Rosamond High Early College Campus Cafeteria Building
SOUTHERN KERN UNIFIED SCHOOL DISTRICT
F&M Project No. 2990
Bid Clarification No.3; Page 1 of 2

BID CLARIFICATION NO. 4

July 18, 2023

OVERALL SITE PLAN

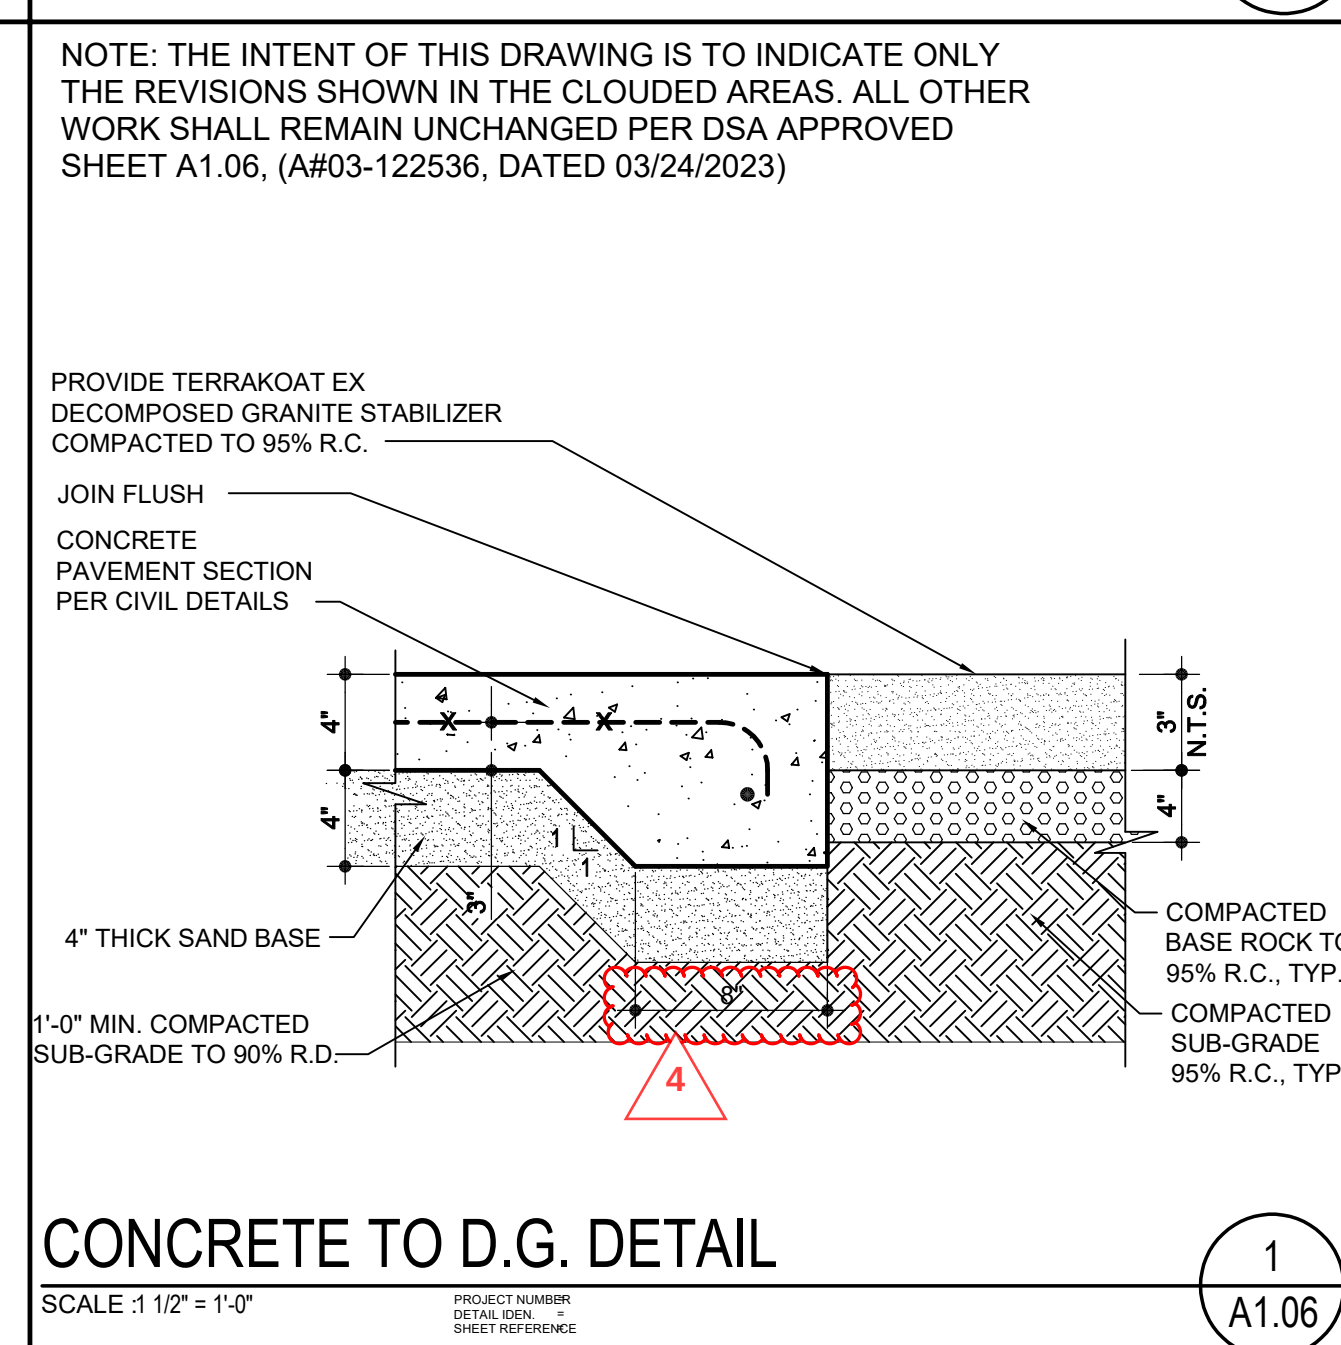
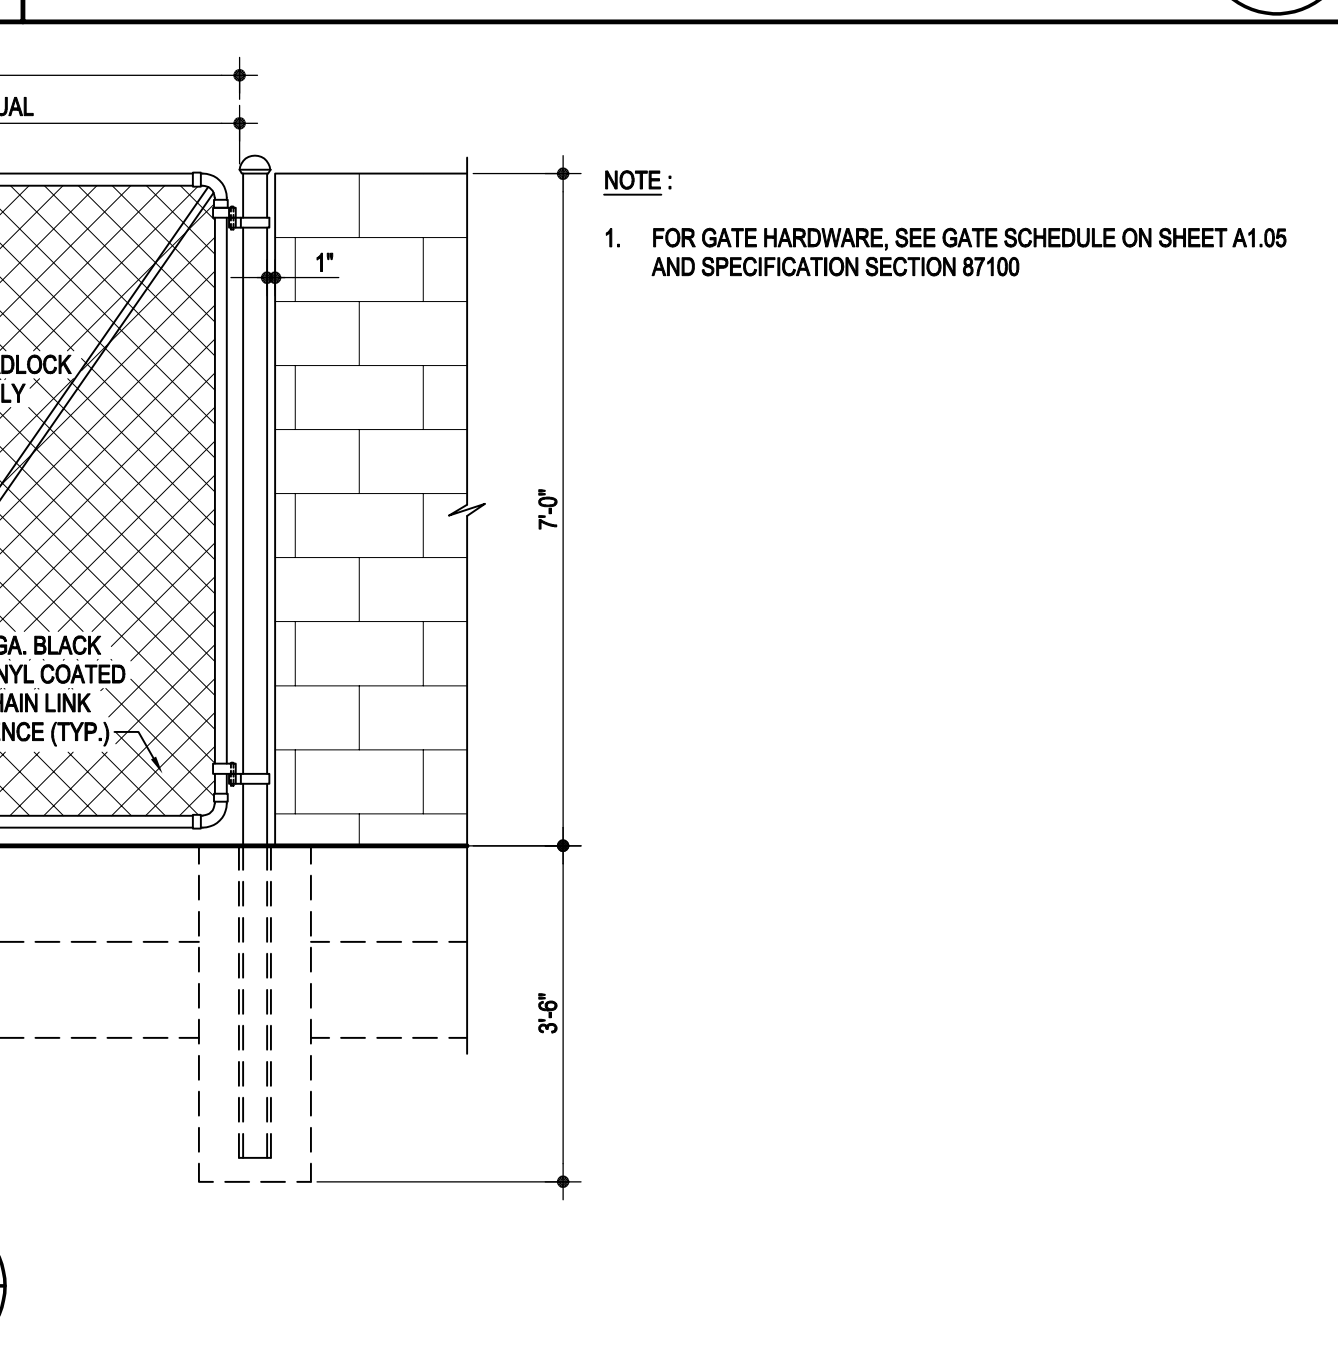
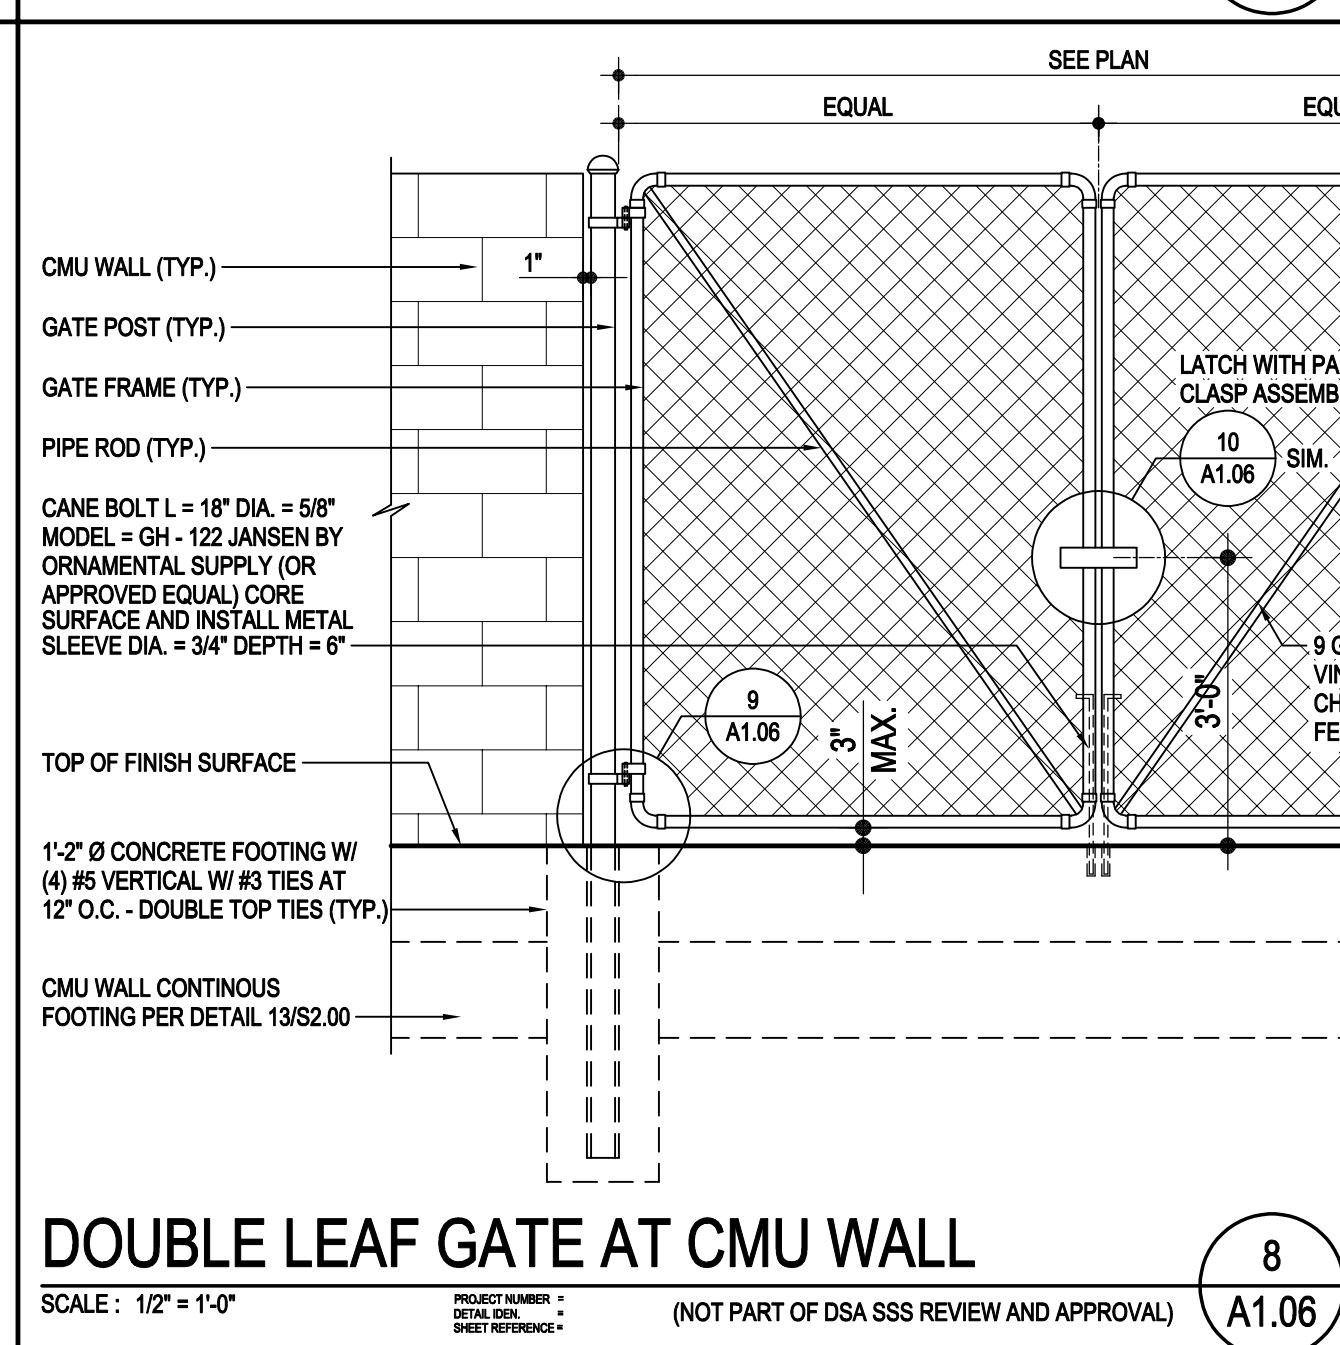
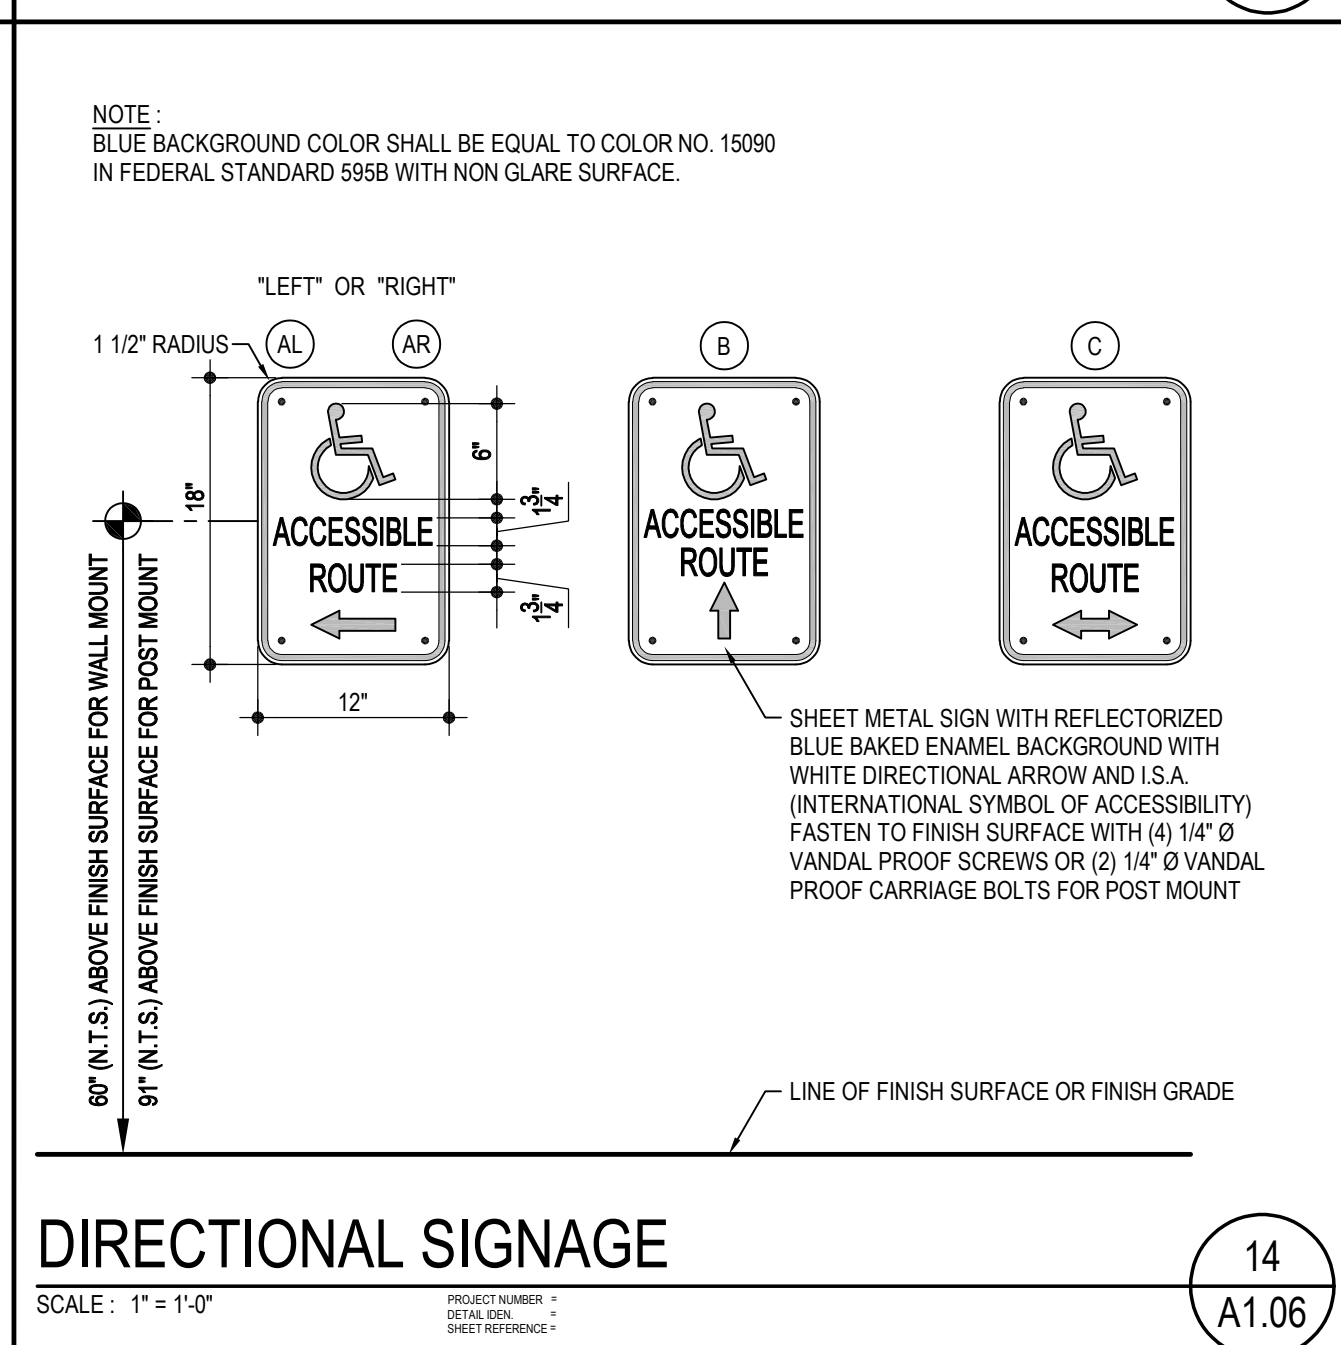
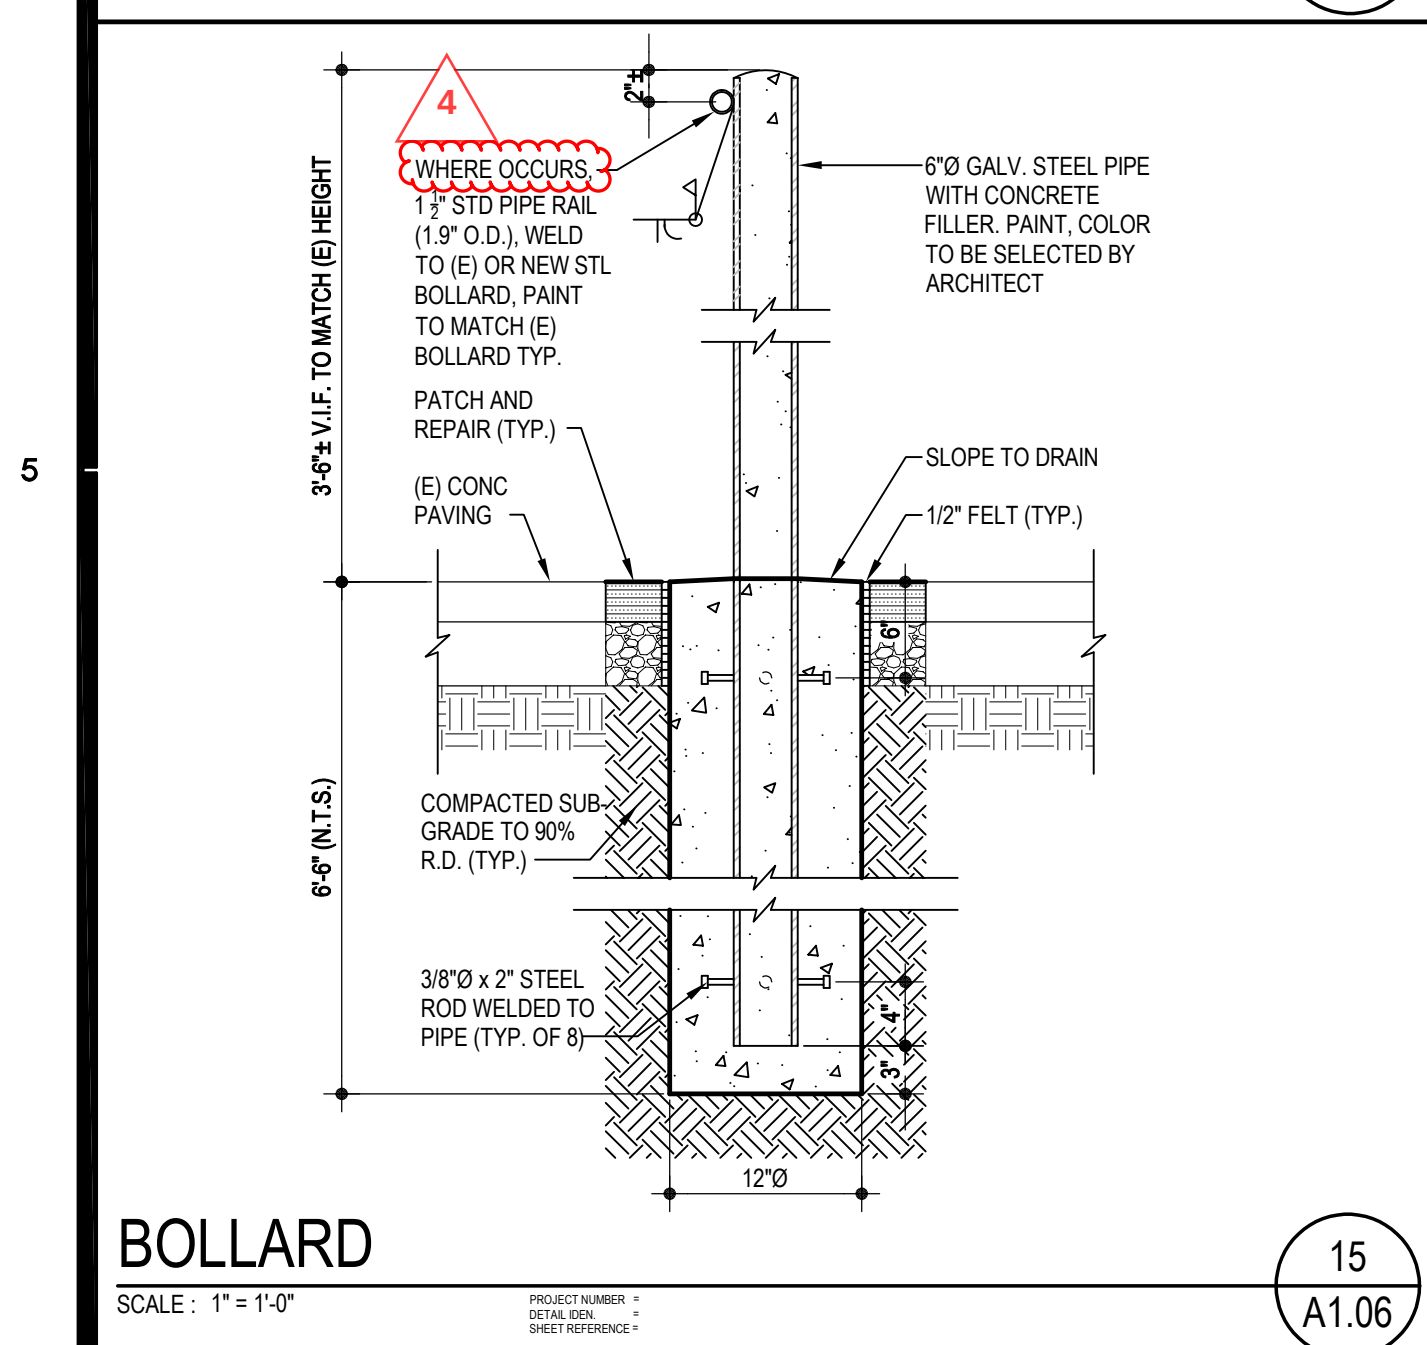
1. A1.04 – Overall Site Plan, "Bid Clarification No.4", with revision clouds as attached hereto.
2. A1.06 – Site Details, "Bid Clarification No.4", with revision clouds as attached hereto.
